**From:** Keith Baarsch <kbinsb@gmail.com>  
**Sent:** Friday, October 15, 2021 11:30 AM  
**To:** City Clerk Group  
**Subject:** Hollister Ave Roundabout  
**Attachments:** 031219-Goleta-Roundabout-Map-JM-1080.jpg

# Ekwill Street and Fowler Road Extensions Project – Proposed Improvements Along Hollister Avenue

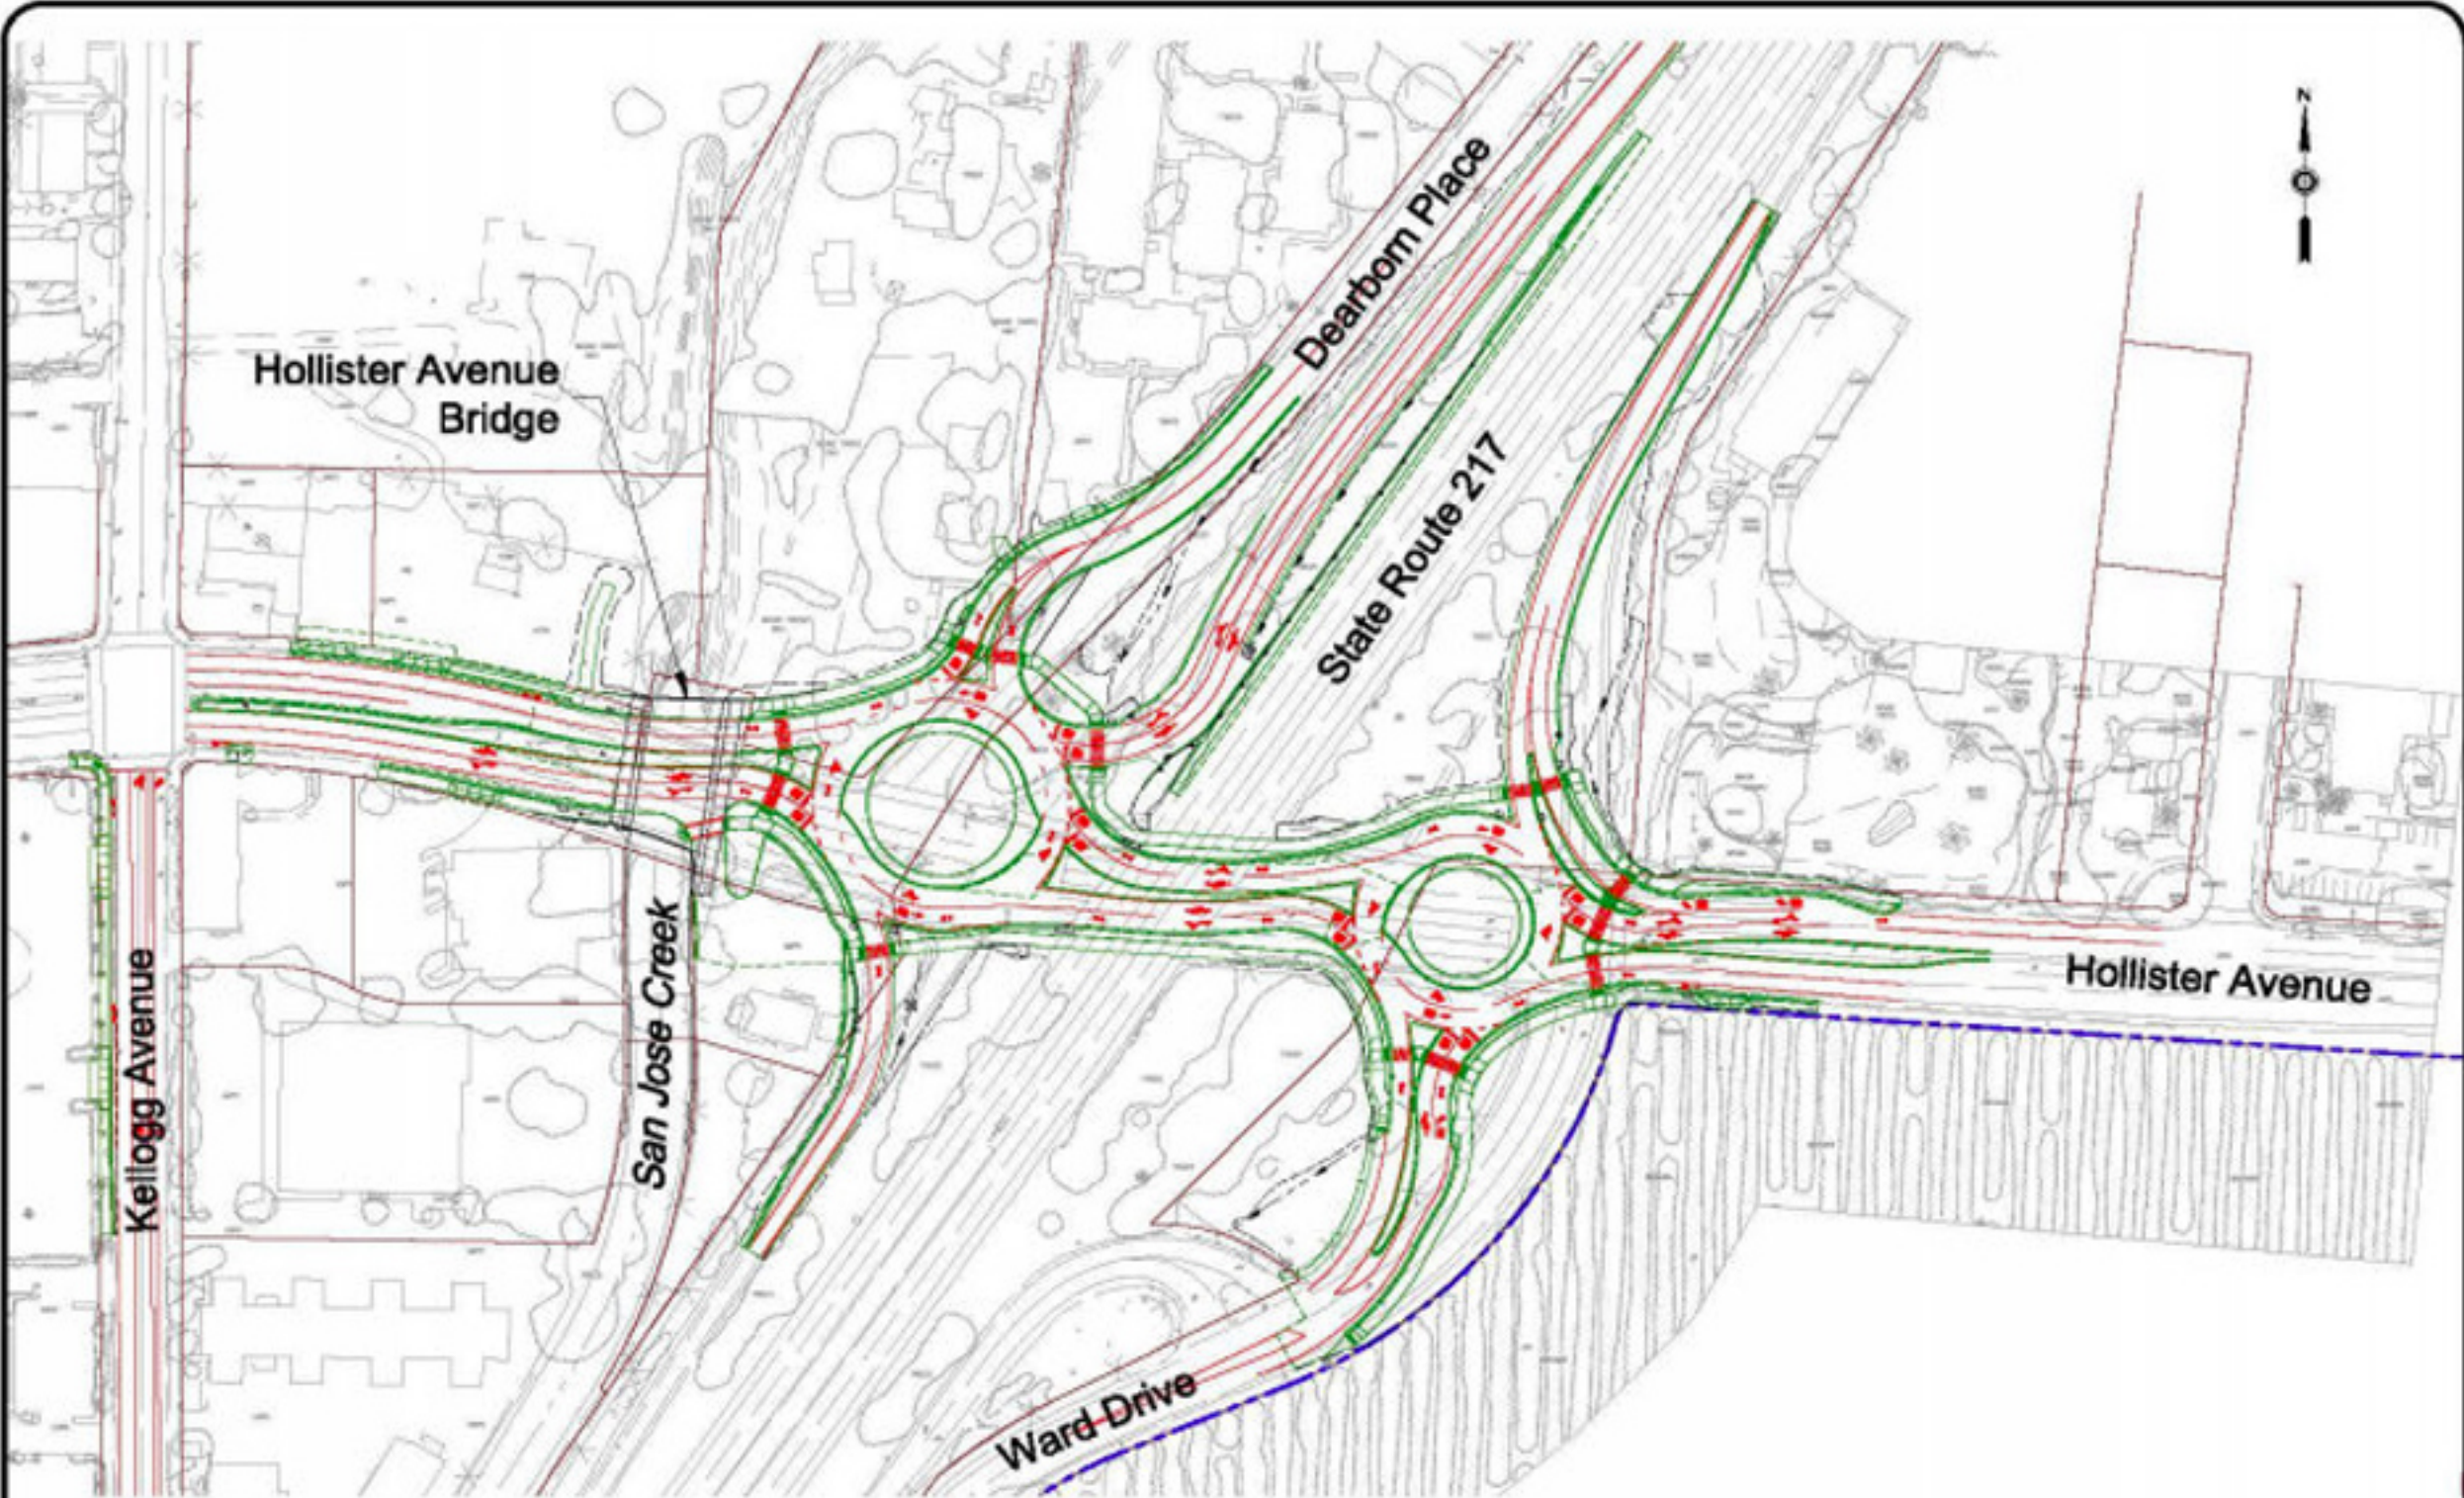
I am a resident of Rancho Goleta Lakeside Mobile Home Park on vWard Drive. I have a few concerns with the roundabouts on Hollister Avenue. My concern is will a new mobile home coming from 101 to Ward Drive will it be able to make the turns. Some of the mobilehome alone are over 60'long. If they have to drive over a center island to make the turn it might break the trailer axles. Also the roundabout to the on ramp to 217 might be a problem for the old homes leaving.

I have also talked with John Givens (John Givens Farms on Ward Drive) and he said he gets truck tractor doubles and this may also be a problem. I have attached a picture of the roundabouts.  
Thank you for your consideration.
